Attachment A

Response to Request for Additional Information

13 November 2020

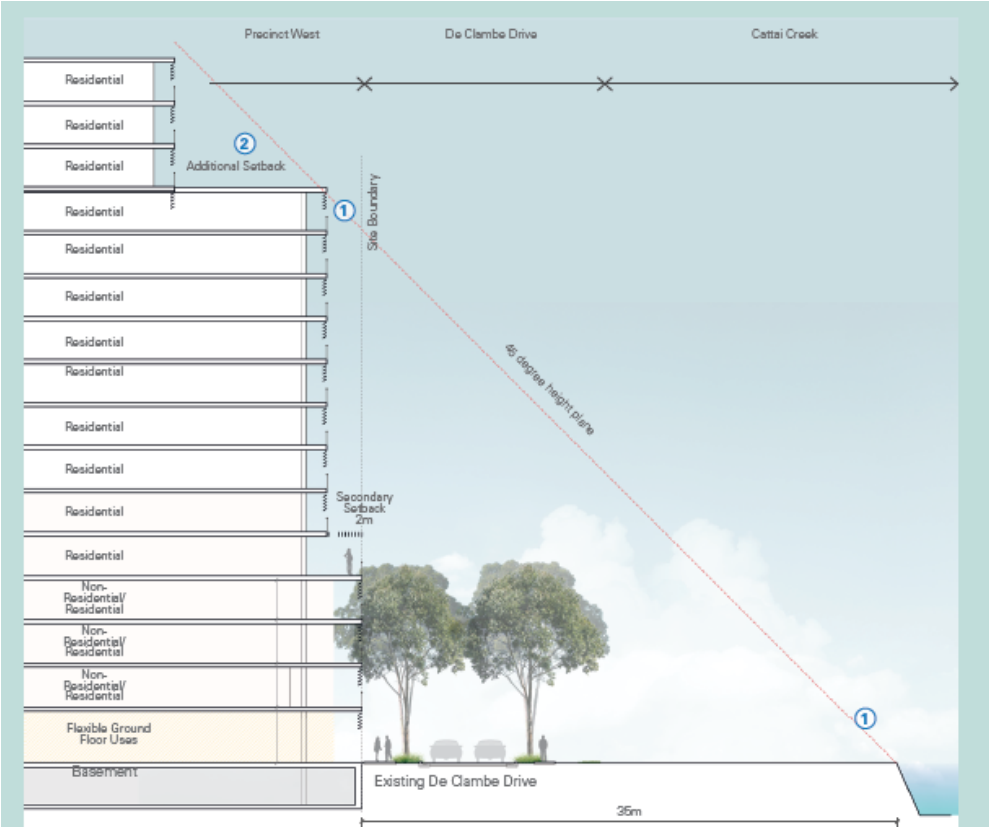
Item	Request for additional Information	Project Response	Annexure Reference
		 <p data-bbox="712 925 1832 981"><i>Figure 1: Urban Design Guideline Building Separation - Original vs Amended Comparison (COX Architecture, 2020)</i></p>	
Design Guidelines	(i) Clarify the discrepancies between the reference to secondary setbacks in the Design Guidelines and the proposed building envelopes, including any projections such as balconies.	The podium allows for a secondary setback of 3-metres and includes balconies or other projection/ external finishes to be located within the podium space.	Annexure B – Urban Design response to RFI – page 11 Annexure C – Urban Design Guidelines – Section 5.2.13 and Section 5.2.14

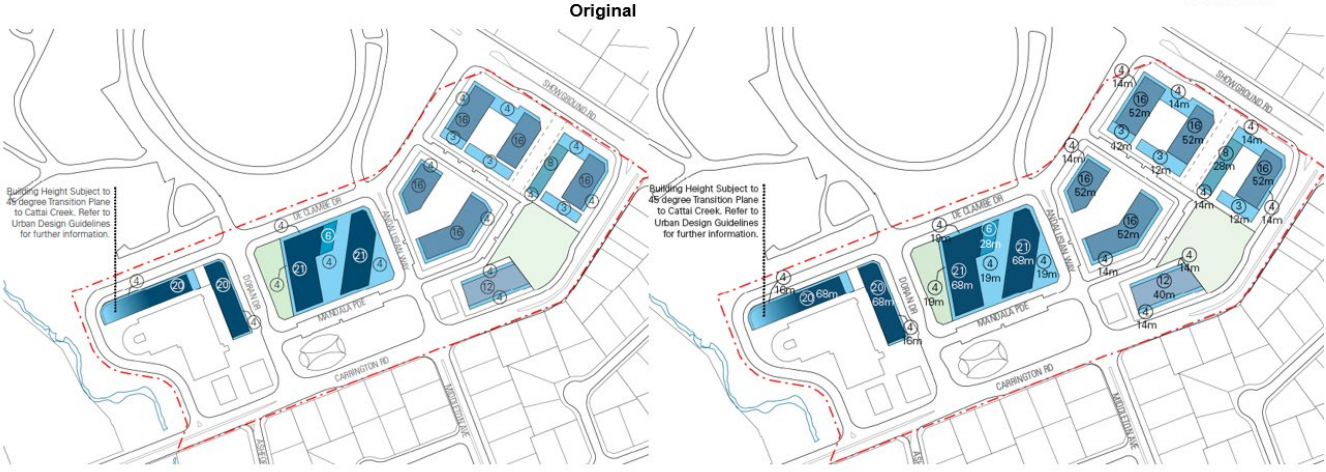
5% of Affordable Housing (81 dwellings)	Proof of Concept Distribution	Maximum Rate Applied as per ARHSEPP 2009	Number of Maximum Spaces	1 bedroom	25%	0.4	8	2 bedrooms	55%	0.5	23	3 bedrooms	20%	1	16		100%		47 spaces	
5% of Affordable Housing (81 dwellings)	Proof of Concept Distribution	Maximum Rate Applied as per ARHSEPP 2009	Number of Maximum Spaces																				
1 bedroom	25%	0.4	8																				
2 bedrooms	55%	0.5	23																				
3 bedrooms	20%	1	16																				
	100%		47 spaces

Item	Request for additional Information	Project Response	Annexure Reference								
		<table> <tr> <td>Visitor Parking</td><td></td><td>1 space per 10 apartments</td><td>8 spaces</td></tr> <tr> <td>Total Affordable Housing</td><td></td><td></td><td>55 spaces</td></tr> </table> <p>The table shows that 55 spaces are required for the 81 Affordable Housing dwellings, this results in a reduction of 26 spaces (81 minus 55) to the maximum residential car parking cap of 1,782 spaces (including visitors) totalling to 1,756 spaces (including visitor parking).</p> <p>This maximum residential car parking cap could be further reduced if 'shared parking' were to be applied (1 space per 150 spaces).</p> <p><u>Clarify the maximum car parking rates for the proposed housing and commercial uses</u></p> <p>In summary, the maximum car parking rates for market housing and commercial uses follows:</p> <ul style="list-style-type: none"> Residential (market housing) <ul style="list-style-type: none"> average of 1 space per 1 bedroom average of 1 space per 2 bedrooms average of 1 space per 3 bedrooms 1 visitor space per 10 apartments Affordable Housing as per the <i>State Environmental Planning Policy (Affordable Rental Housing) 2009</i> (except for the visitor parking) <ul style="list-style-type: none"> 0.4 space per 1 bedroom 0.5 space per 2 bedrooms 1 space per 3 bedrooms 1 visitor space per 10 Affordable Housing apartments 	Visitor Parking		1 space per 10 apartments	8 spaces	Total Affordable Housing			55 spaces	
Visitor Parking		1 space per 10 apartments	8 spaces								
Total Affordable Housing			55 spaces
